REMARKS

AMENDMENTS TO THE DRAWINGS

Figure 1

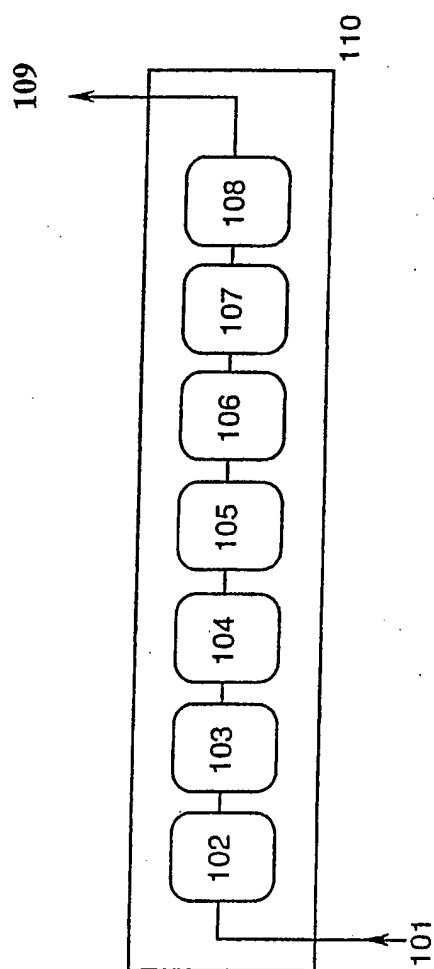
20 The Examiner objected to the drawings under 37 C.F.R. §1.84(p)(5) because reference signs in Figs 1-3, and 6 were either mislabelled or missing. Applicant has amended the drawings and submitted replacement sheets for Figs 1-3, and 6.

In Figure 1:

Replace reference sign "609" with "109".

Figure 2

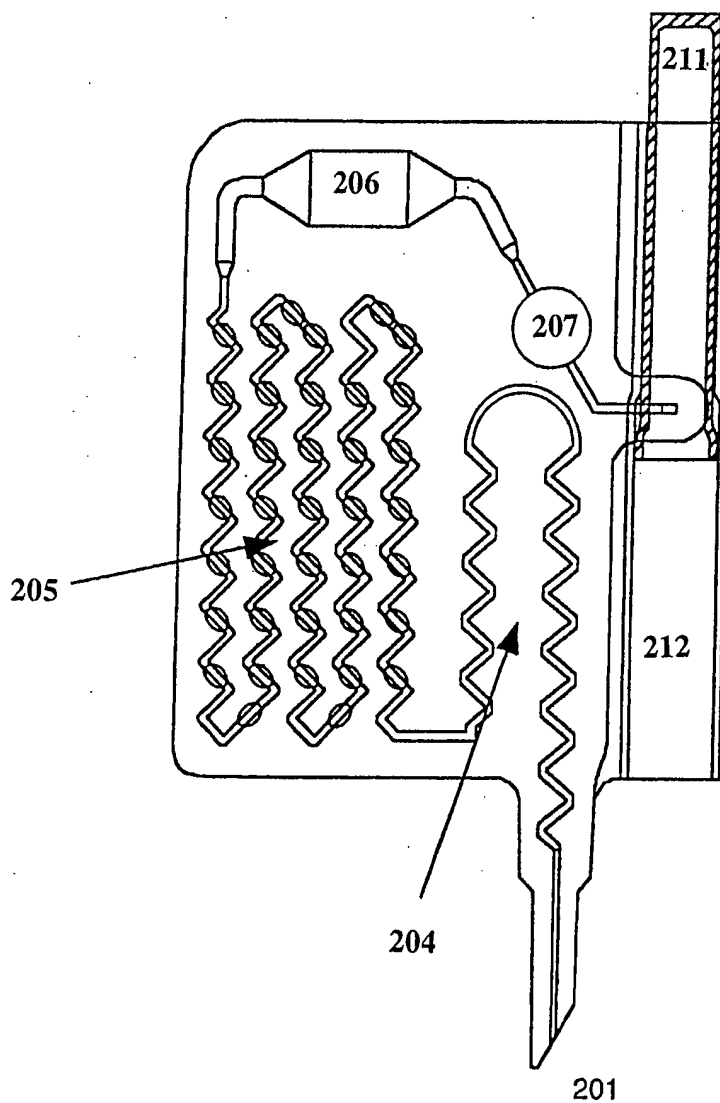
In Figure 2:

Replace reference sign 202 with 204;

Replace reference sign 203 with 205;

Replace reference sign 204 with 206;

10 Replace reference sign 205 with 207;

Replace reference sign 206 with 211; and

Replace reference sign 207 with 212.

Figure 3

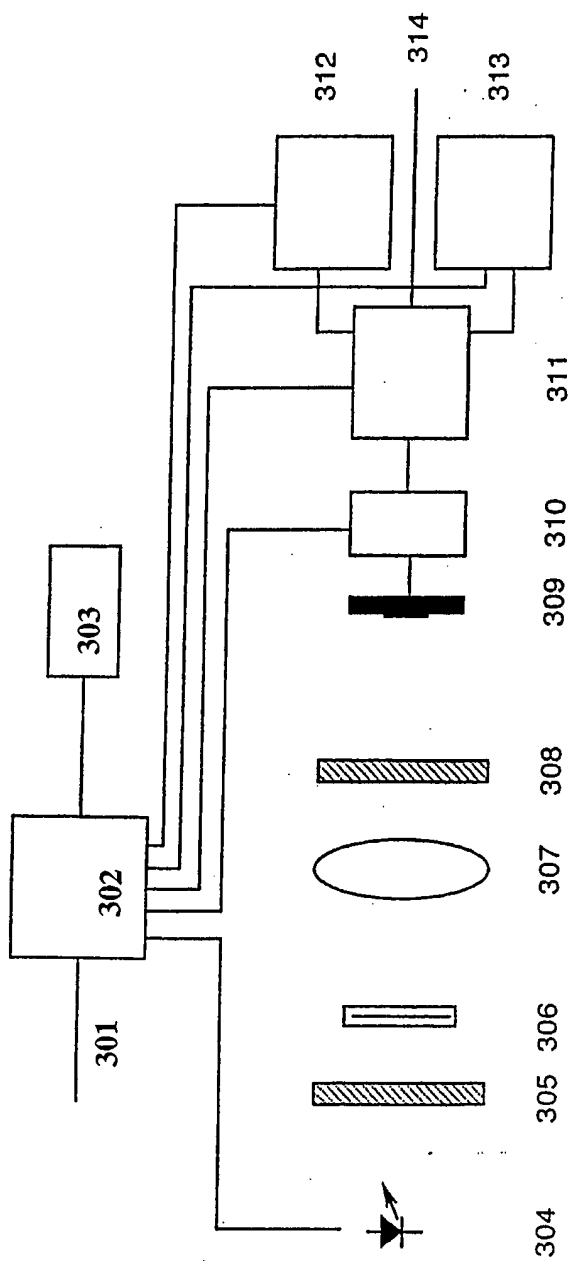
In Figure 3:

15 Replace reference sign 801 with 301;

Replace reference sign 802 with 302; and

Replace reference sign 803 with 303.

Figure 6

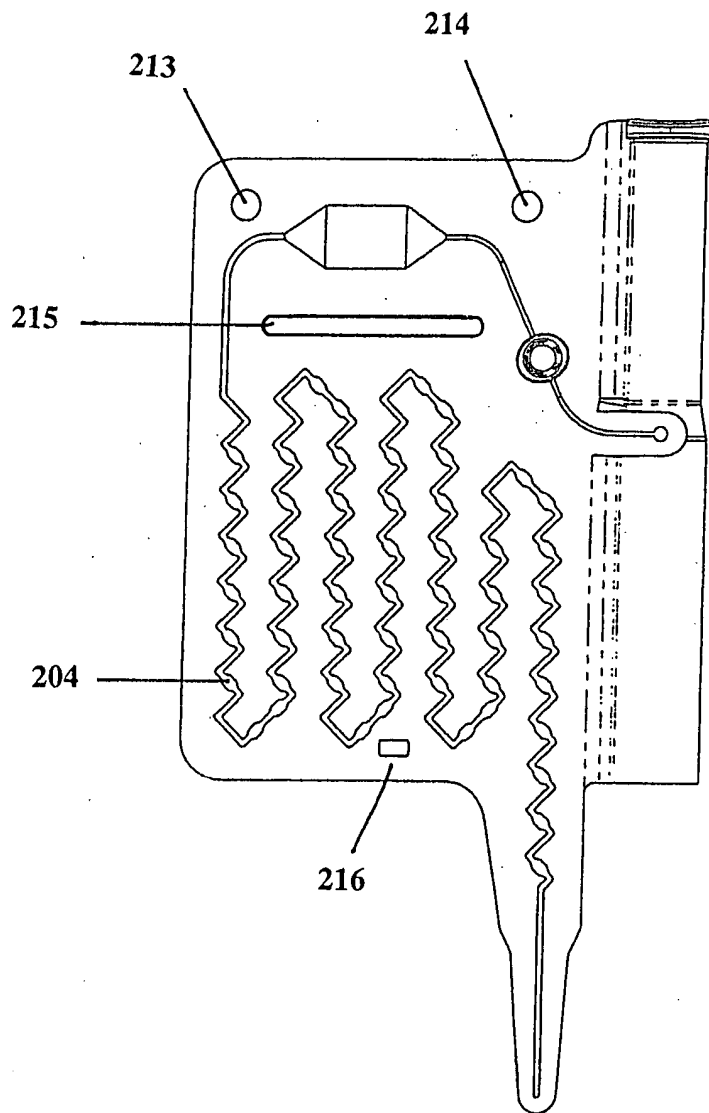
In Figure 6:

20 Add reference sign 204, 213, 214, 215, and 216 where
indicated in the replacement drawing.
